August 6, 2010

Re: **Willamette 205 Corporate Park Phase II Extension Request (MISC 10-14)**
Completeness Response
 Project Number 2060016.10

The purpose of this letter is to respond to the incompleteness determination dated July 7, 2010. The following will provide itemized responses to each of the points listed in your letter.

SHEET TITLE:
SITE PLAN

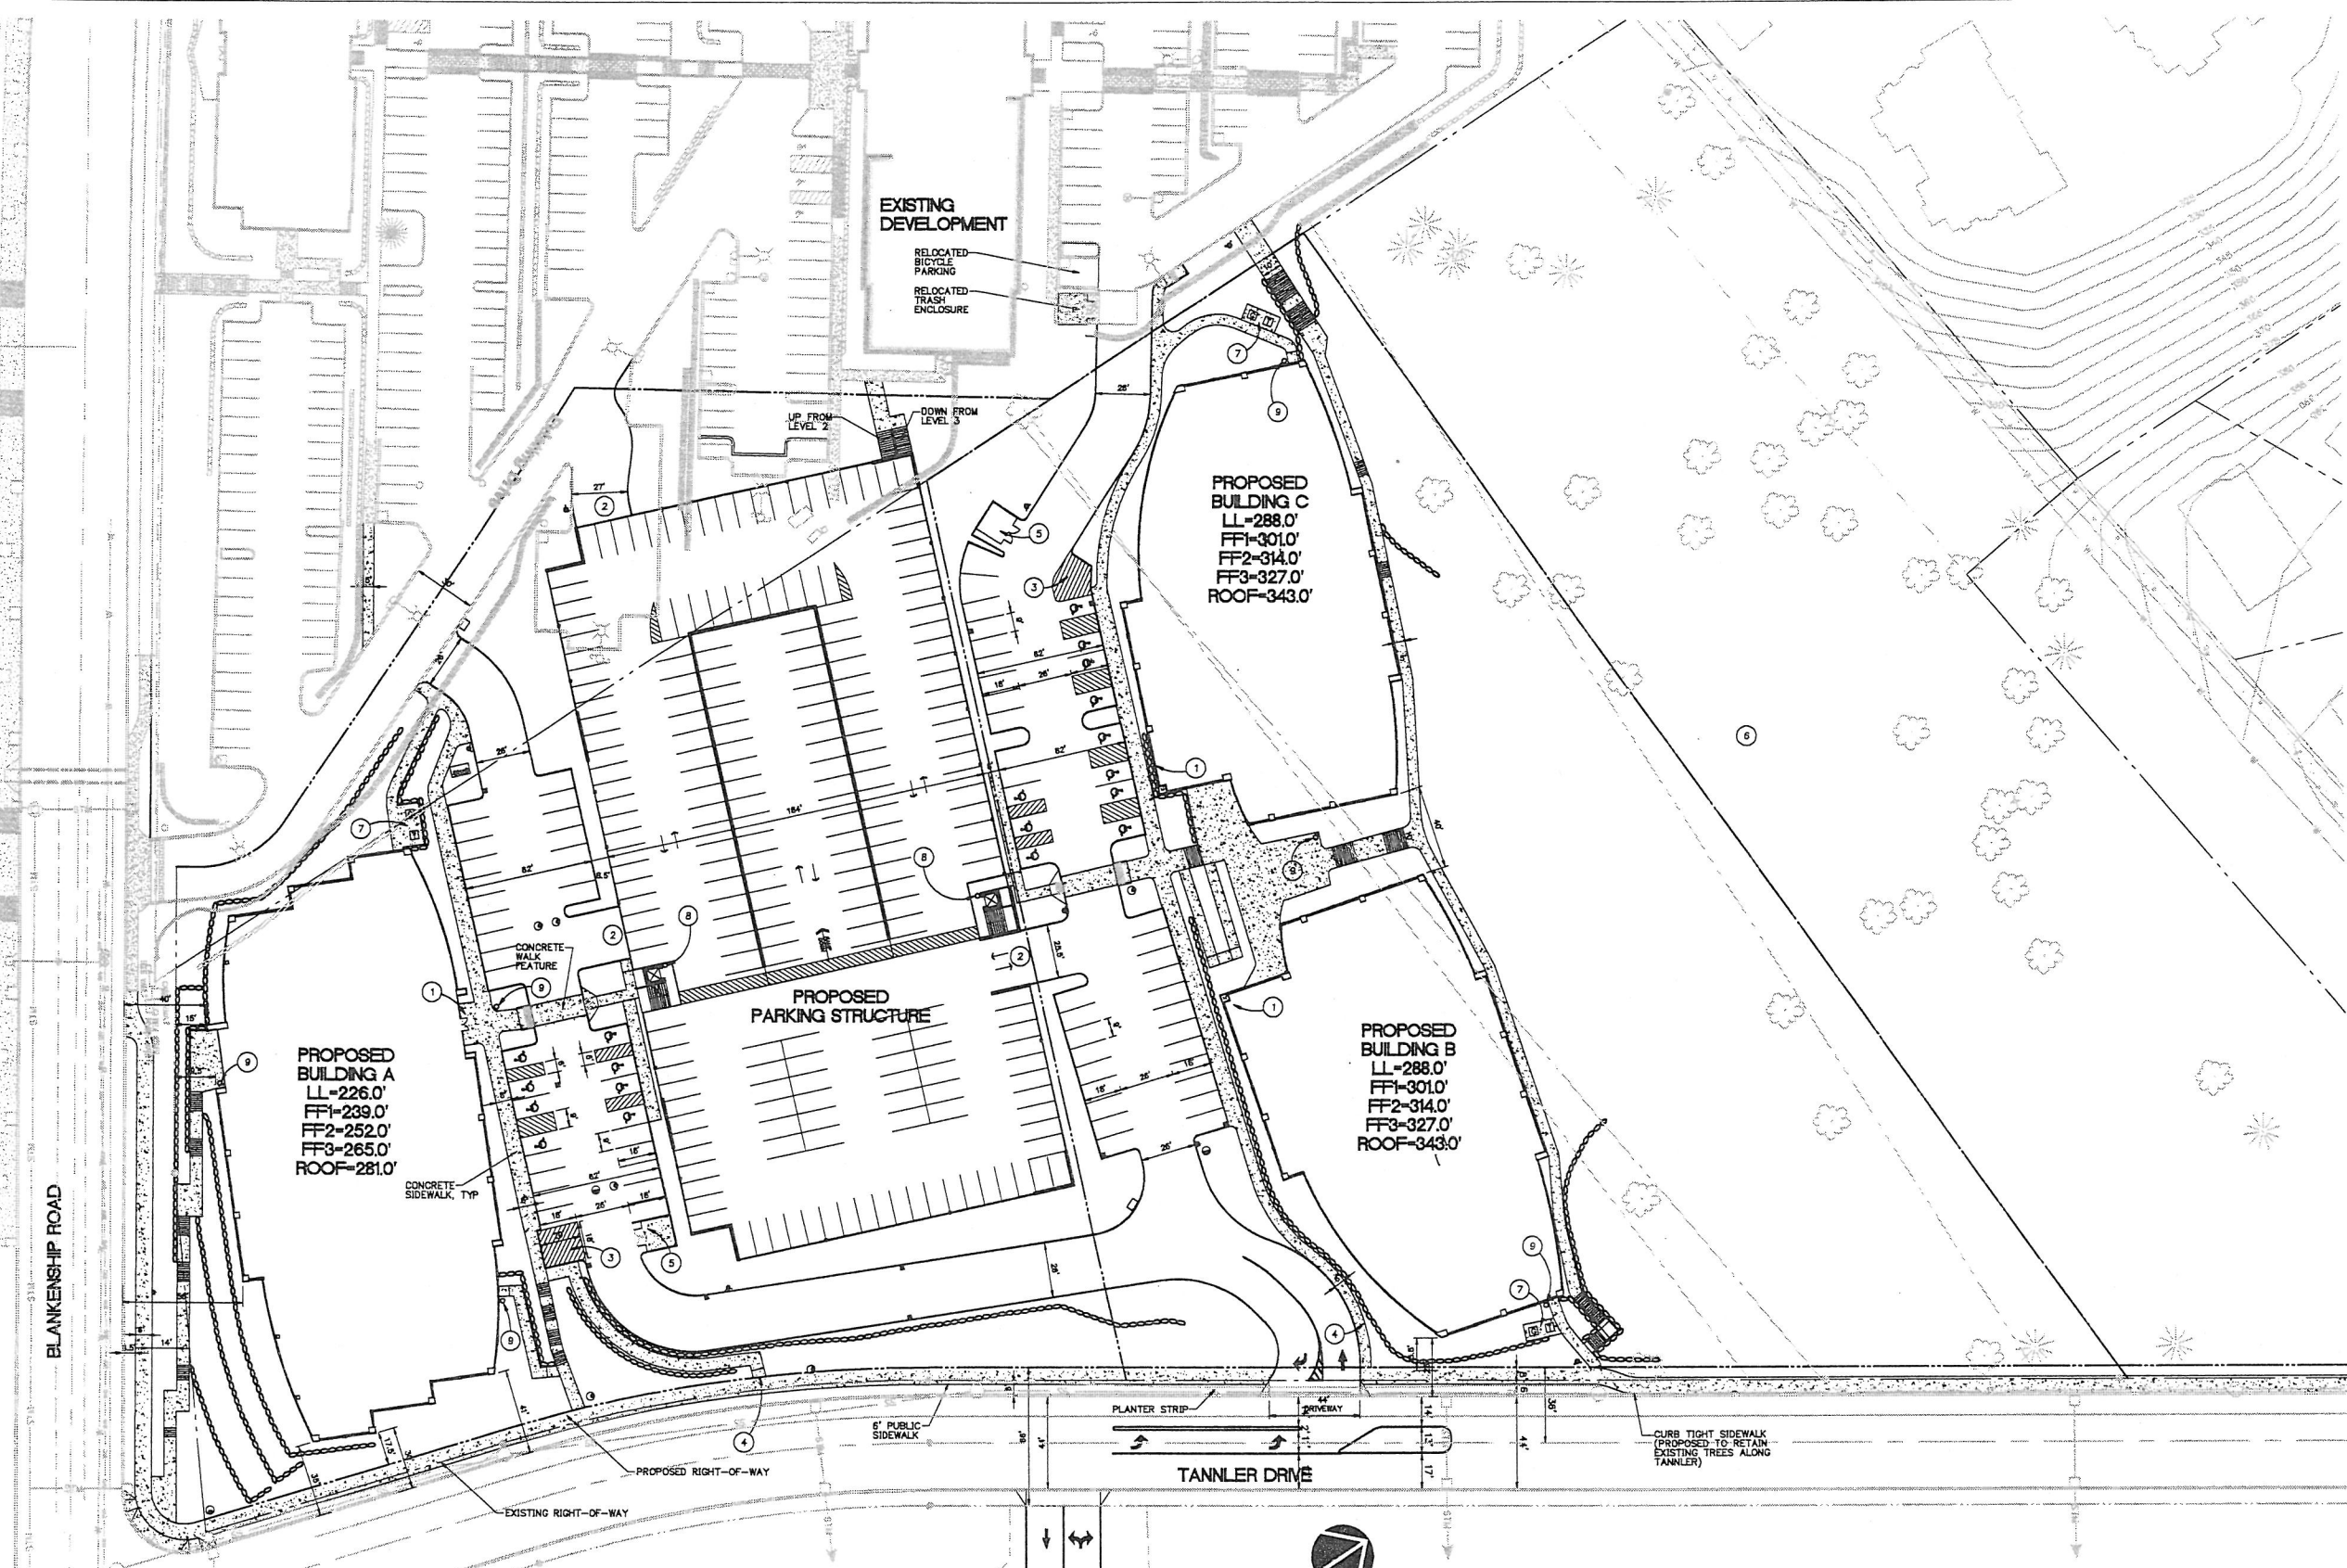
- 1. It appears that [fire] access to the rear of the buildings is inadequate and access is not viewable;*
- 2. please include plan sheet detail with turning radii for fire apparatus;*
- 3. provide fire flow work sheet for all buildings and show hydrant placement.*

Response: Fire access for the site has been demonstrated on sheet C2.2. Proposed hydrant locations have been provided as shown on sheet C4.0. Fire flow worksheets have been provided for all buildings and are attached. Additional water supply information has been provided by Murray Smith that indicates the proposed development will not have an impact on the fire flow availability. This standard is met.
